SUBMISSION ON DRAFT MAMRE ROAD DCP

This letter has been prepared on behalf of the GPT Group (**GPT**) in response to the release of the draft Mamre Road Development Control Plan (**the DCP**) which is on public exhibition from 10 November to 17 December 2020.

This submission is made in respect to GPT landholdings as the owner of **Lot 59-60 in DP 259135, Kemps Creek (the site)**.

Figure 4 Mamre Road Precinct Road Network Map

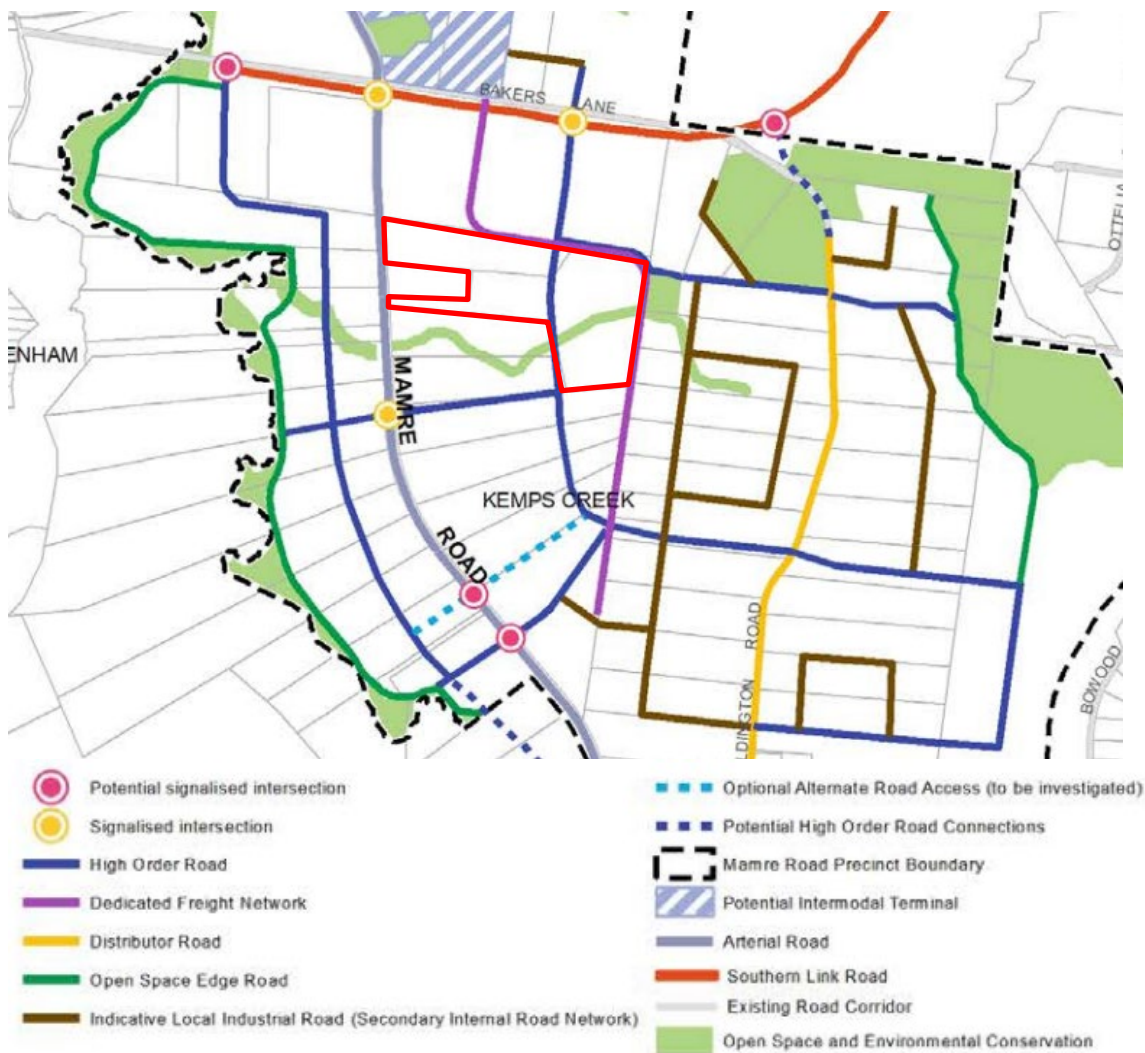
The draft DCP proposes an east west road connection from Aldington to a proposed High Order Road dissecting GPT's land (refer **Figure 4** below).

This east west road is a replacement of the Aldington entry / exit to the Southern Link Road. ASON Group are undertaking traffic modelling-which is due in late January / early February 2021. Further clarification is required for road reserve widths for 'High Order Roads' or 'Open Space Edge Roads'.

Initial traffic modelling forecast's the East West Connection will carry low levels of traffic movements. It is also suggested that the Aldington entry exit to Southern Link Road (SLR) is required. The road structure plan must consider the final endorsed modelling results as well as the impacts of the cost to deliver and the loss of developable land which subsequently reduces employment.

1. Clarification of road reserve widths for 'High Order Roads' and 'Open Space Edge Roads' should be provided in the DCP.
2. The DCP should provide flexibility to enable variations to the road network and road defined functions subject to final LU19 Traffic modelling.
